Subject: **License Amendment Request**

The enclosed license amendment request for ABB's NRC License No. SNM-1067 proposes to incorporate a name change for the licensee from "ABB Prospects Inc." to "ABB Inc.", and to make other administrative and minor technical revisions to update the license to the contemporary status of the CE Windsor Site. Decommissioning financial assurance remains extant (ABB letter to NRC May 19, 2006).

**Enclosure I**

**Description of Proposed Changes**

Figure 6-3

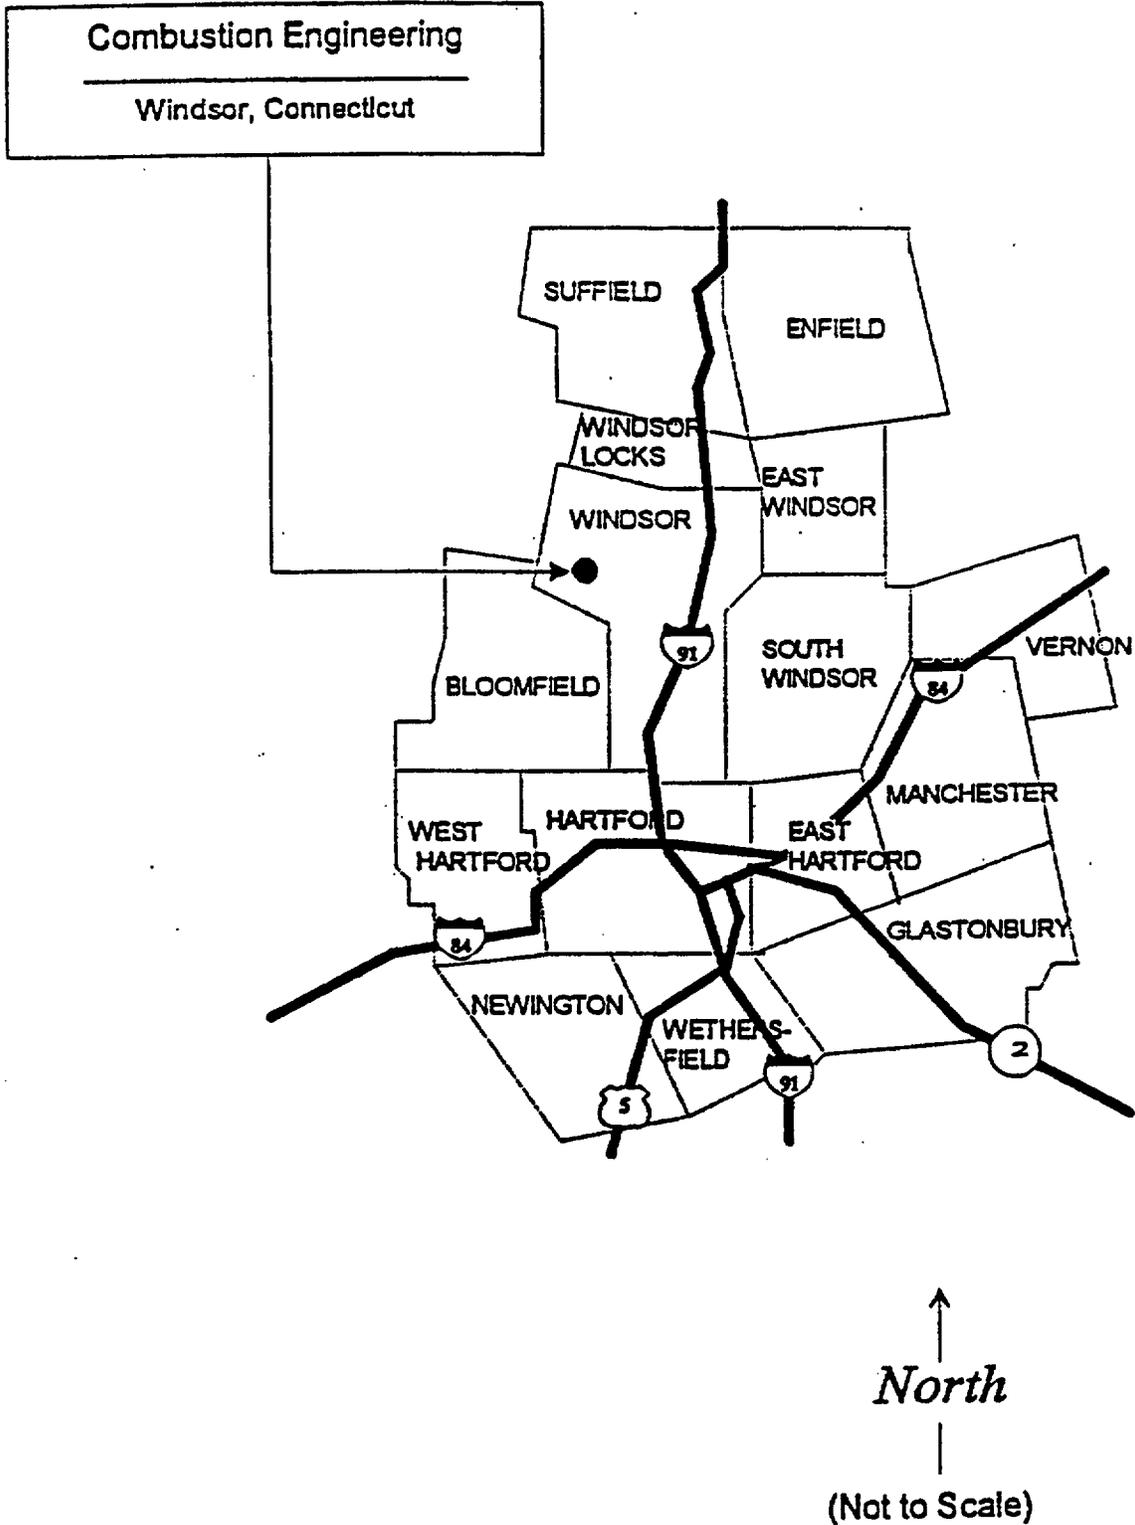
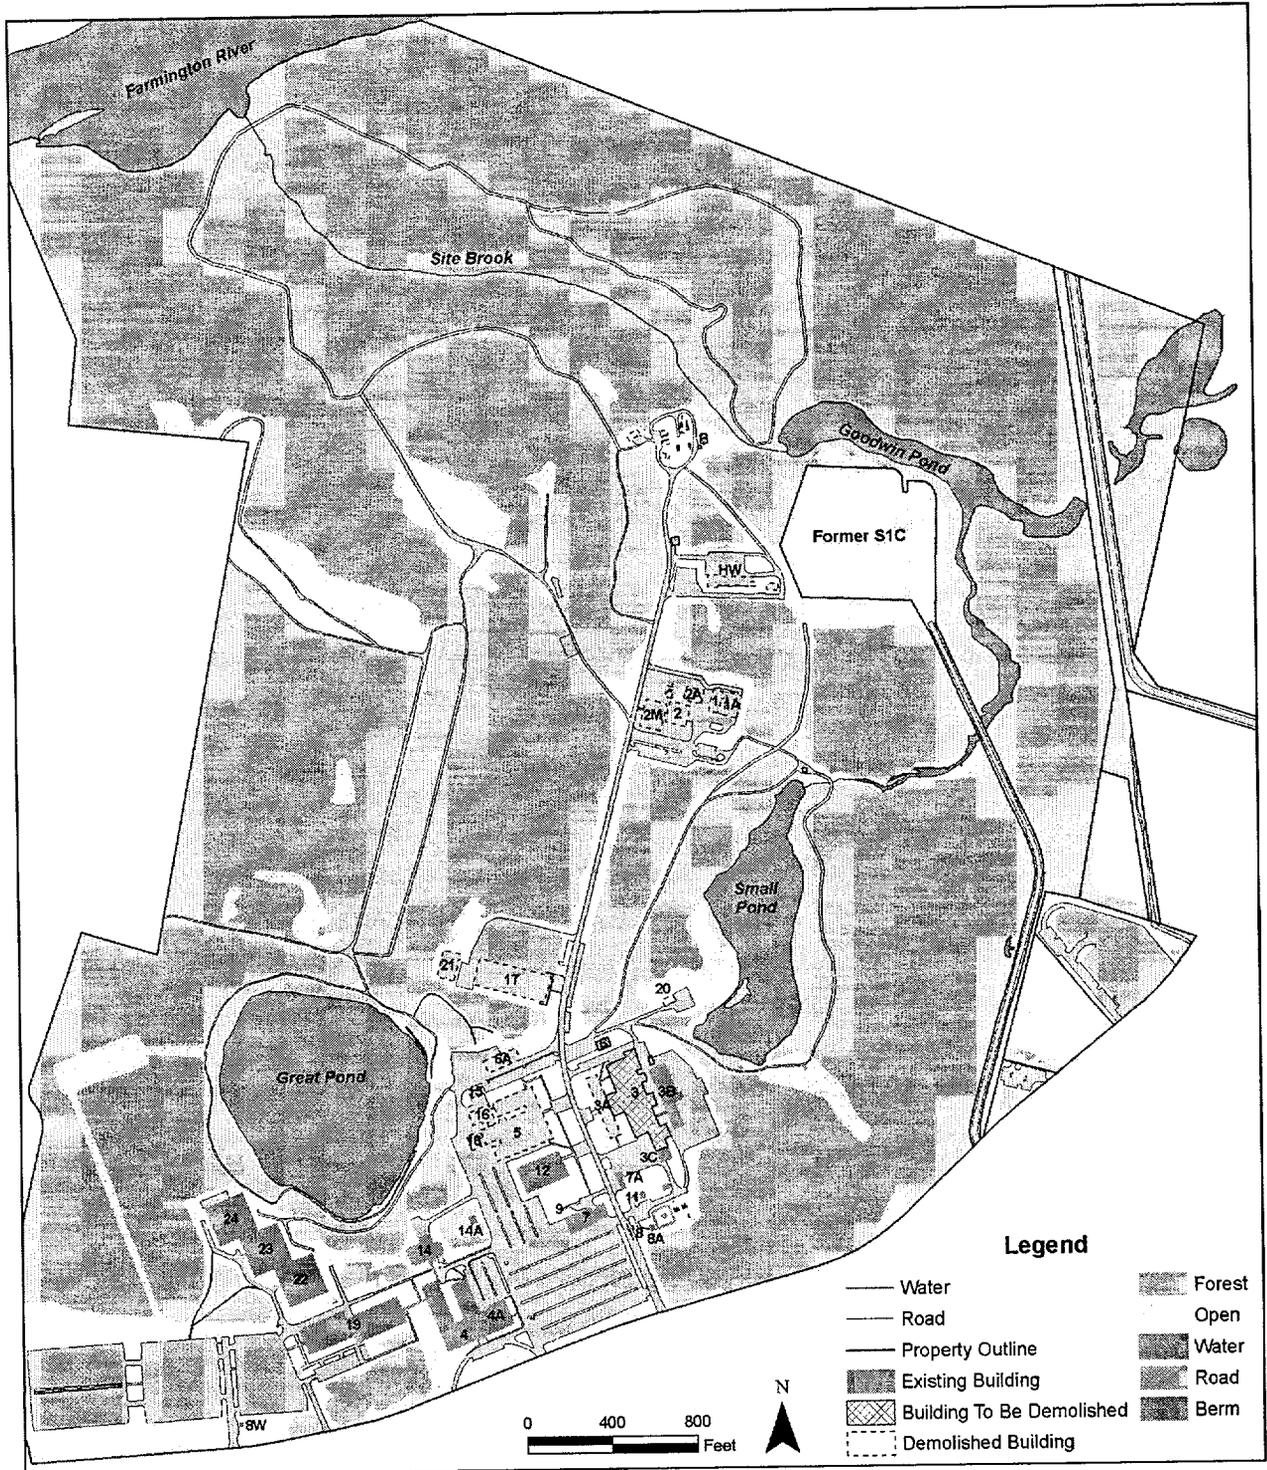
- Page 6-9, Figure 6-3: Figure is upgraded to current quality.
- Page 8-4, Figure 8-1: Change “Environmental Control & Support” to “ABB Inc.” to be consistent with NRC License No. 06-00217-06.
